Office Action Summary

10/519,280

WEISS ET AL.

Vinh T. Luong

ATTACHMENT 1

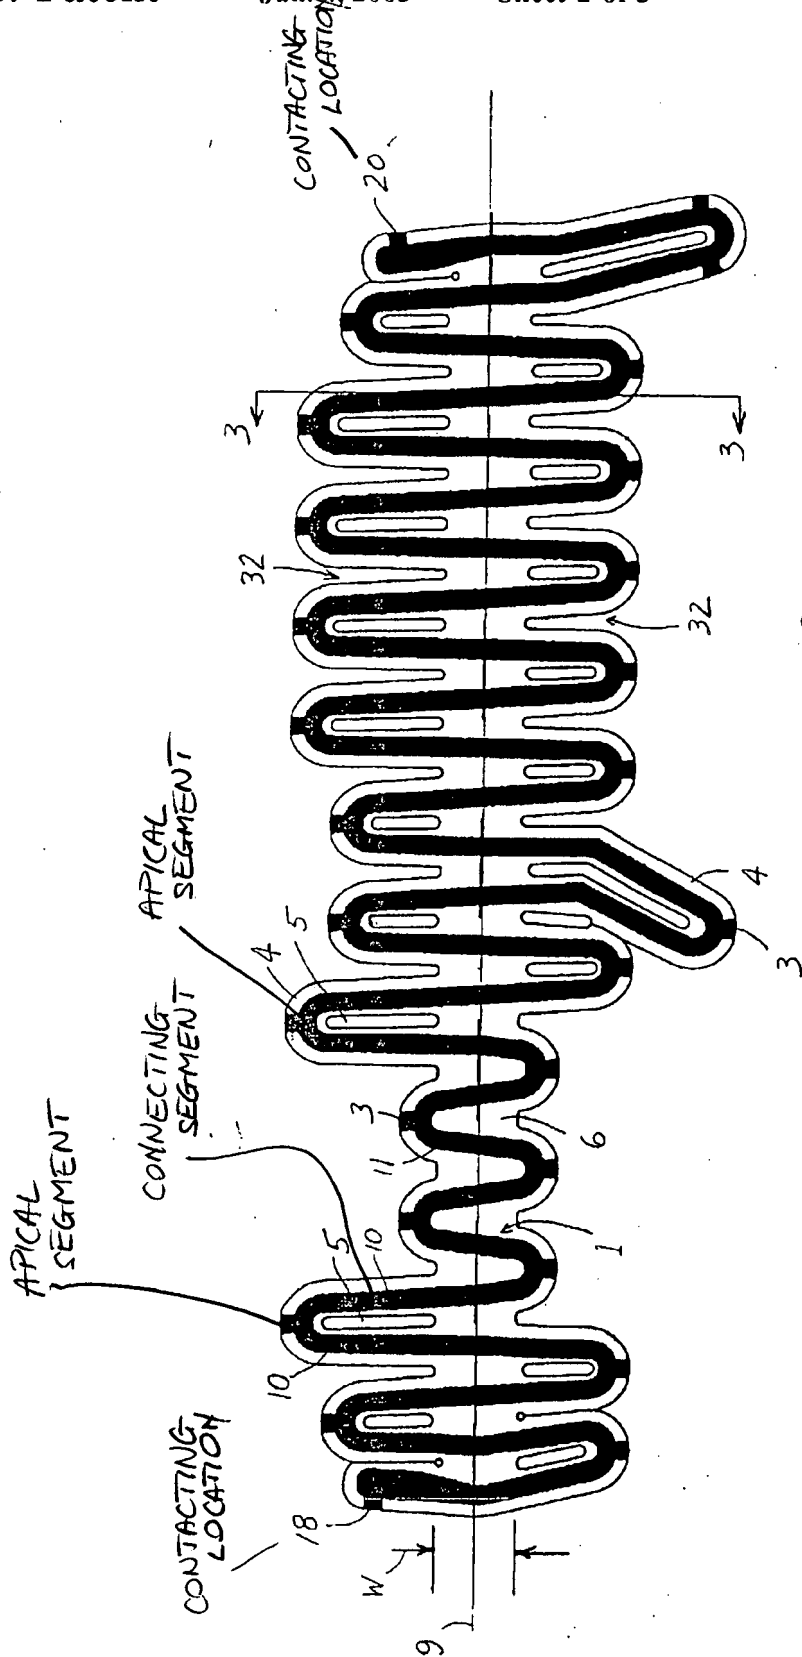
Regarding Claim 1, Nagele teaches a heating element (FIG. 2) comprising an electrically conductive layer 1 with a meandering contour (id. col. 2, line 56+) along a lengthwise direction of the heating element, wherein the heating element is cropped from a substantially continuous segment and wherein the electrically conductive layer 1, at its apical segments (at 4 in FIG. 2,

see Attachment 1 hereinafter "Att. 1"), is widened in each instance compared to a connecting segment (at 10 in FIG. 2, see Att. 1).

Regarding Claim 5, the apical segments (Att. 1) of the electrically conductive layer 1 or the heating element, comprise a rounding radius.

Regarding Claim 6, an envelope 4, 30 (FIG. 3) of the apical segments (Att. 1) arranged on one side of the direction 9 of lengthwise extension of the heating element 1 overlaps (FIG. 2), said apical segments (Att. 1) each remains distanced from each other.
